**R614-301-500  
ENGINEERING  
APPENDIX**

**VALLEY CAMP OF UTAH, INC.  
SCOFIELD ROUTE, HELPER, UTAH 84526**

Re: Mid Permit Term Review  
Belina Complex ACT/007/001

MID-PERMIT REVIEW SUBMITTAL  
OF JANUARY 16, 1987

TITLE: UTAH NO. 2 POND- STAGE CAPACITY & CURVE  
 SCALE: NONE  
 DRAWING NO. B-3- 0033

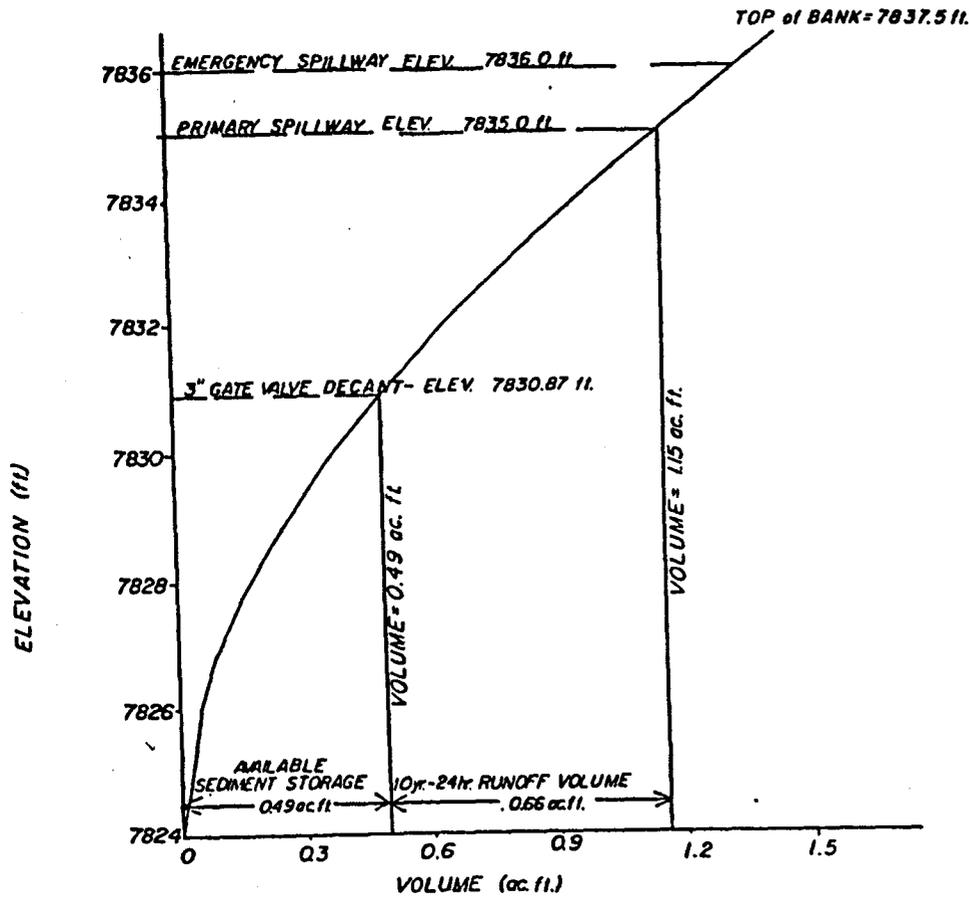
- 817.46  
[784.16  
(b) 1 &  
2] New page no. 10B-1, showing the new capacity of Sediment Pond No. 2, is enclosed for insertion behind page no. 10B of this section. New page no. 10B-2, Drawing No. B3-0033, "Utah No. 2 Pond-Stage Capacity and Curve," is also enclosed for insertion.

In August of 1985, Valley Camp enlarged the No. 002 sediment pond at Utah No. 2, to a total capacity of 1.31 acre feet. A composite of the individual capacities are as follows:

Figure 3-6E

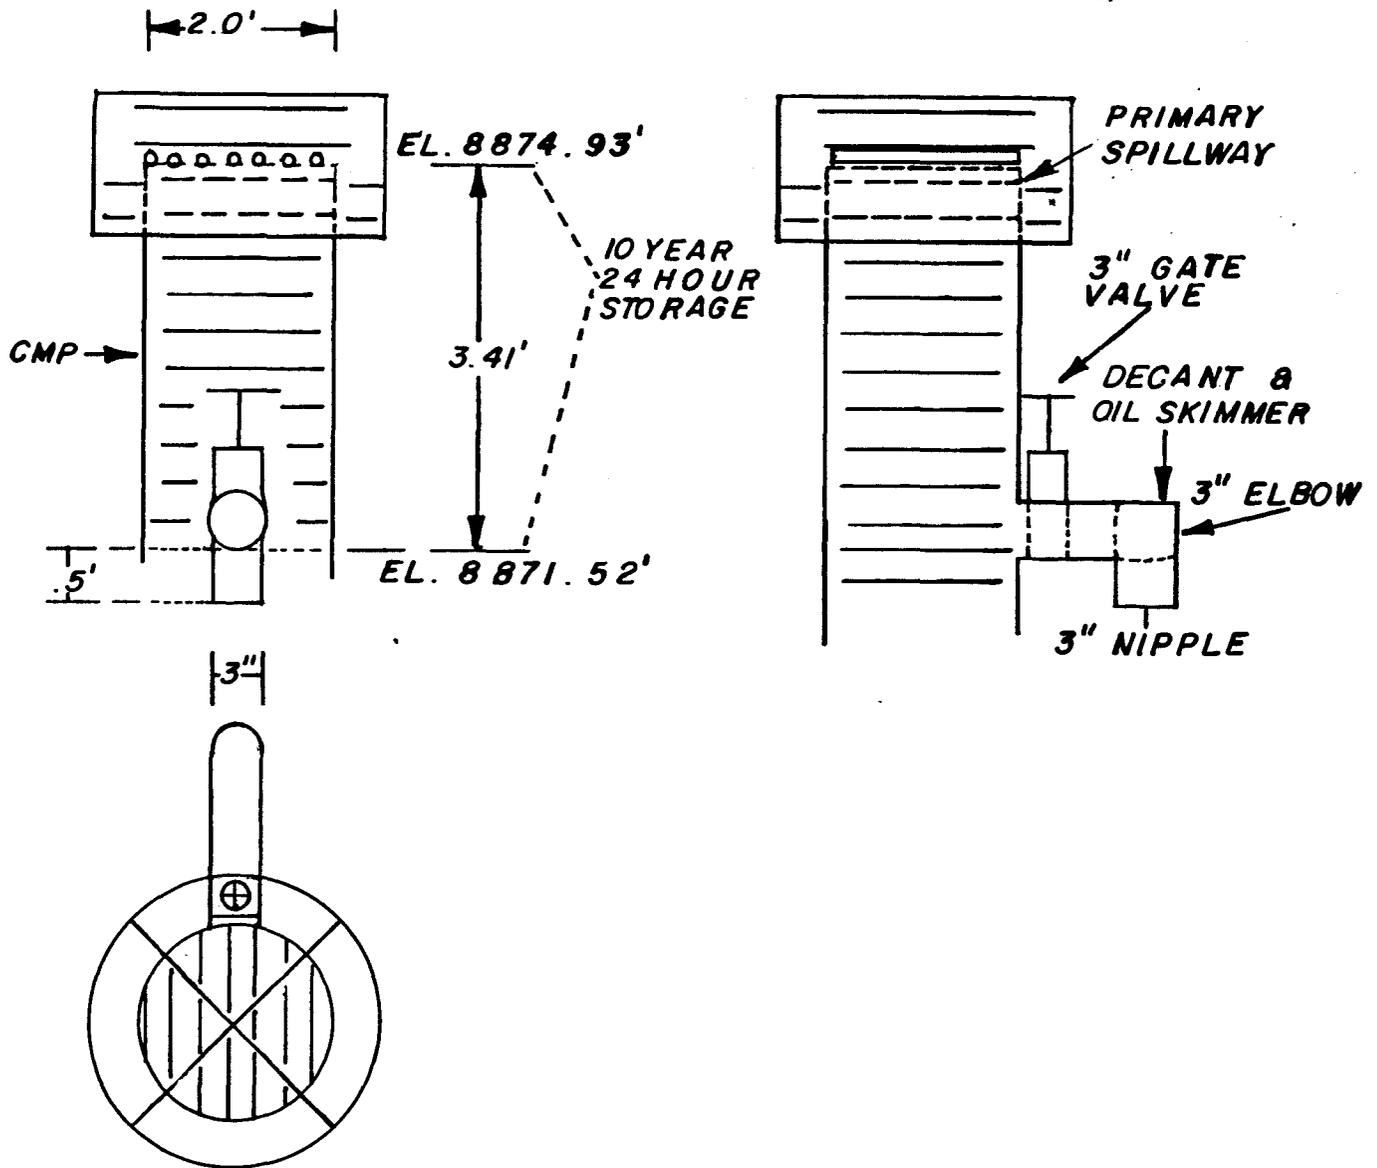
- 784.12 A new drawing, No. B3-0020, for typical gabion structures, is enclosed as Figure 3-6D, page no. 20D.
- 784.12 A new drawing, No. A4-0092, for typical decant pipes, is enclosed as Figure 3-6E, page no. 20E.

Figure 3-6G

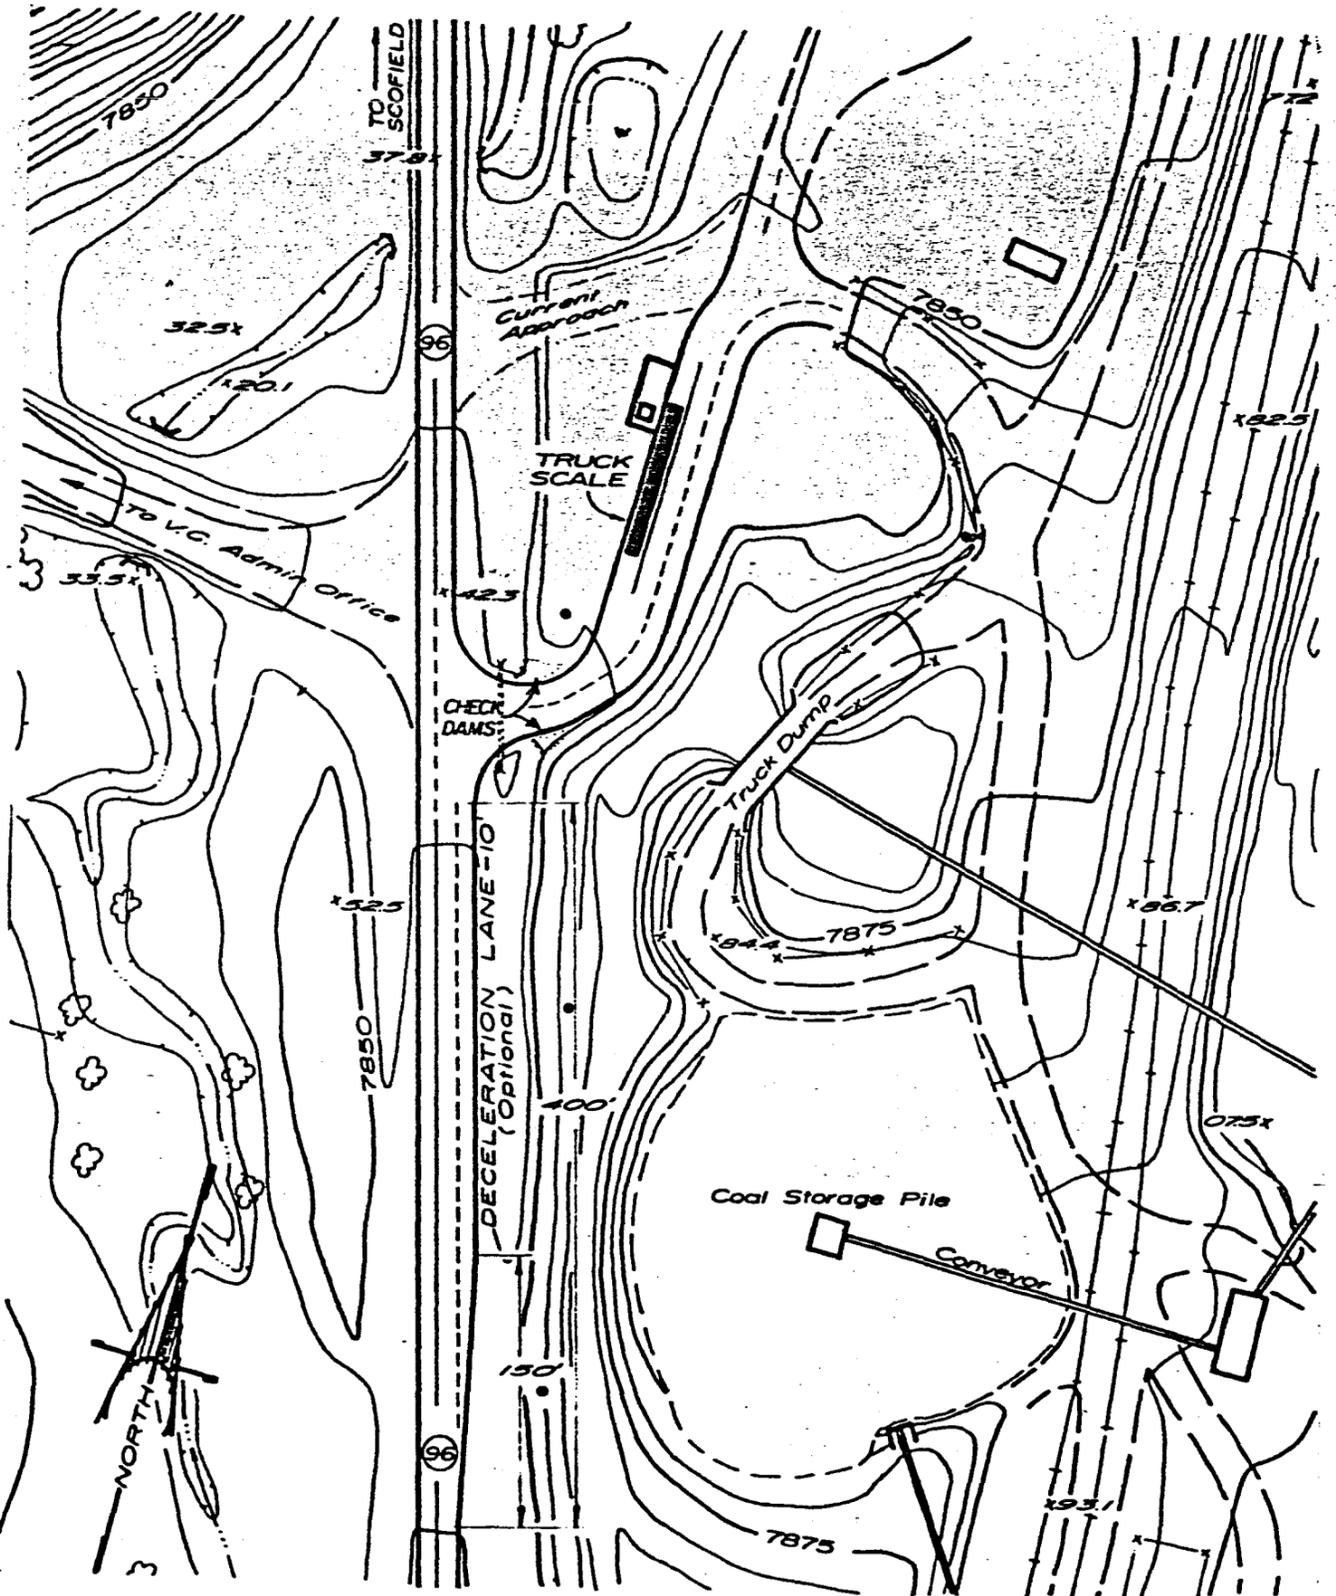
- 784.12 A new drawing, No. B4-0038, "Belina Mine Wash Bay and Retaining Wall," is enclosed as Figure 3-6F, page no. 20F.
- 784.12 A new drawing, No. A4-0056, "Truck Scale Location and Approach - Utah No. 2," is enclosed as Figure 3-6G, page no. 20G.

Figure 3-6C

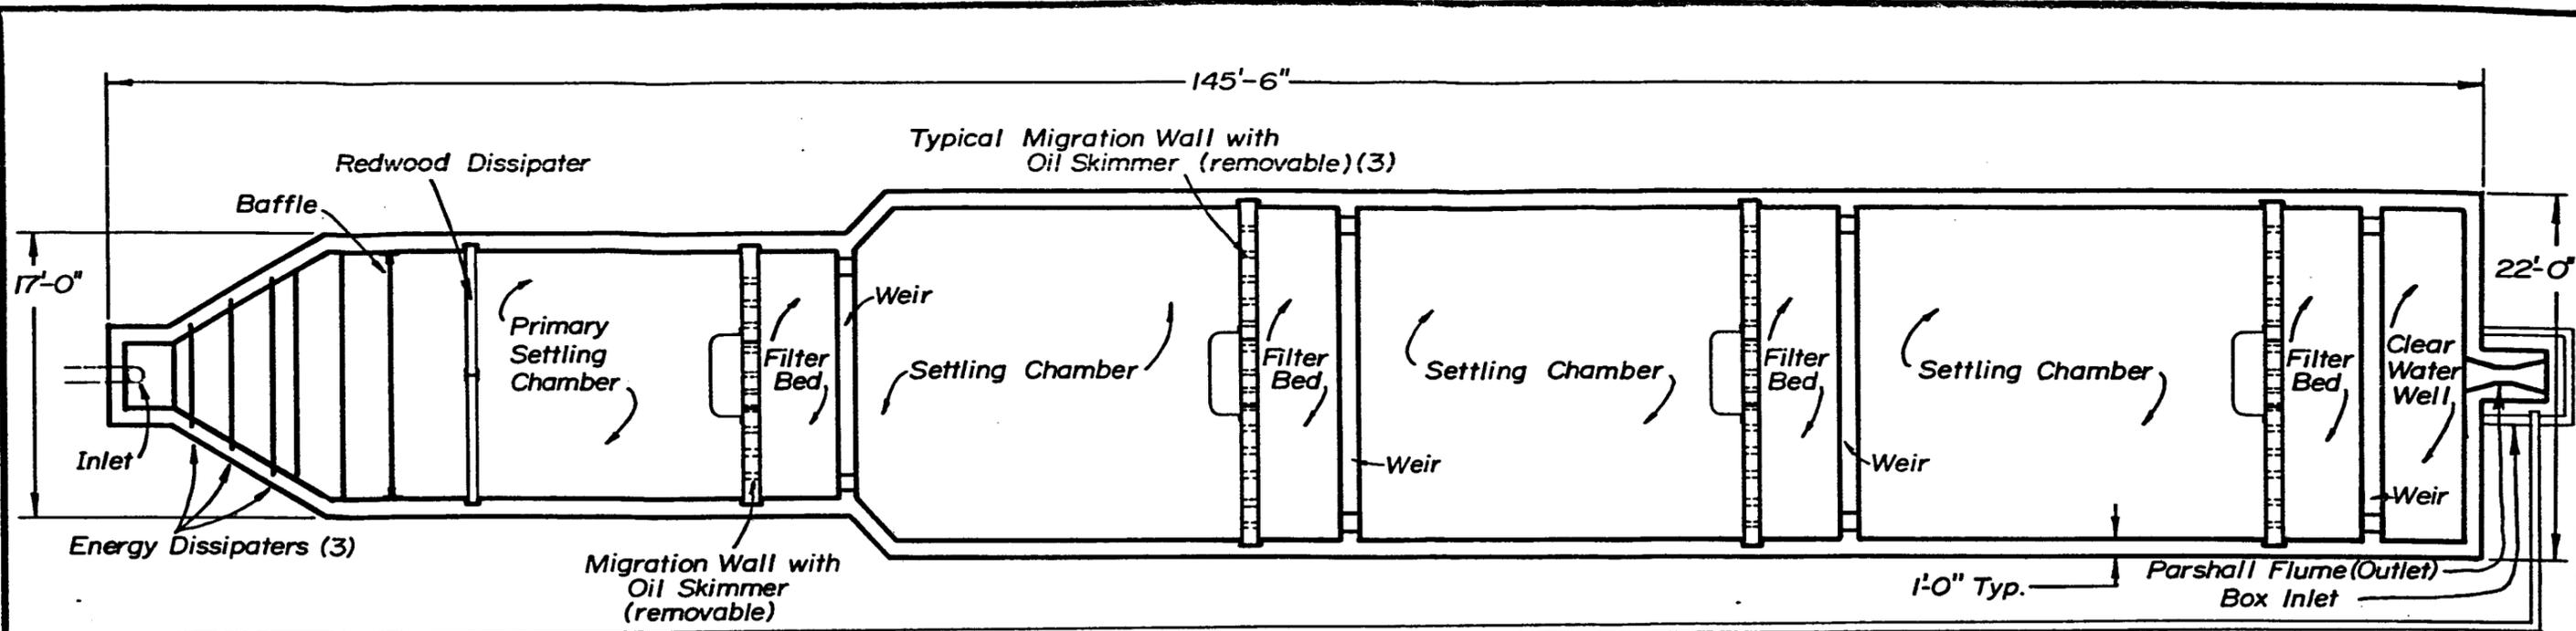
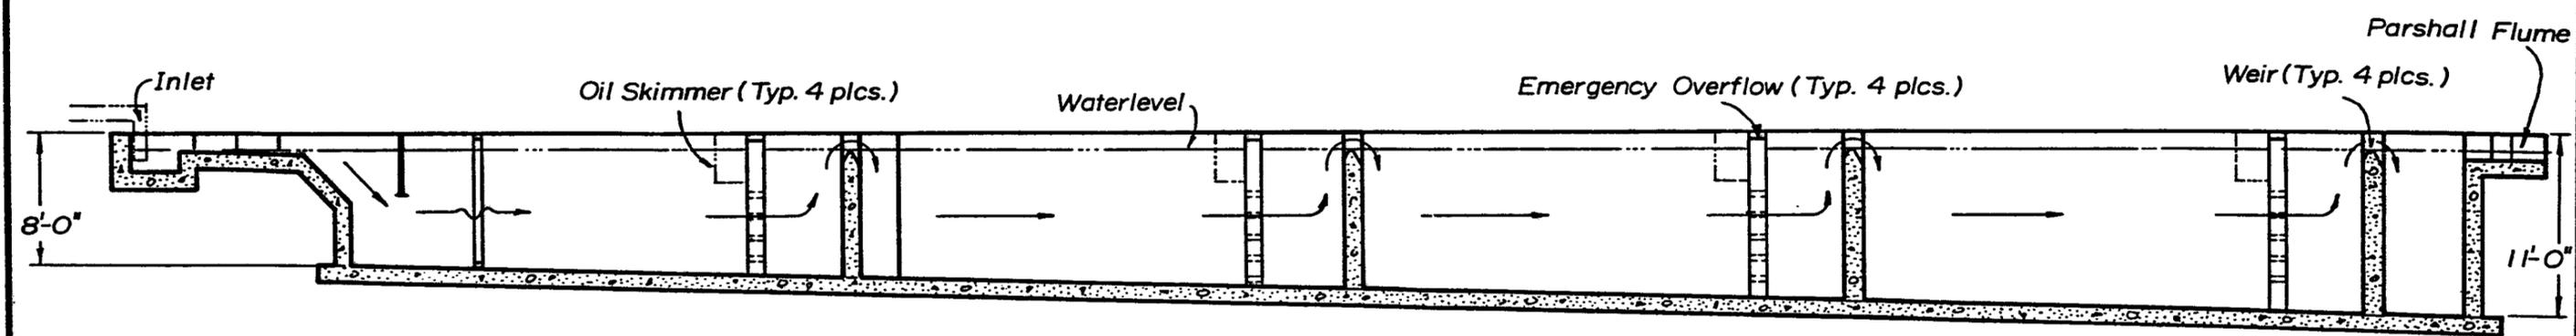
- 784.12 Revised page nos. 13 through 15 are enclosed as replacements. This revision reflects the change in frequency of sediment pond inspections.
- 784.12 A revised drawing, No. B4-0010, "Concrete Filter Pond," is enclosed as Figure 3-6C, page no. 20C, for replacement of that figure presently in the plan.
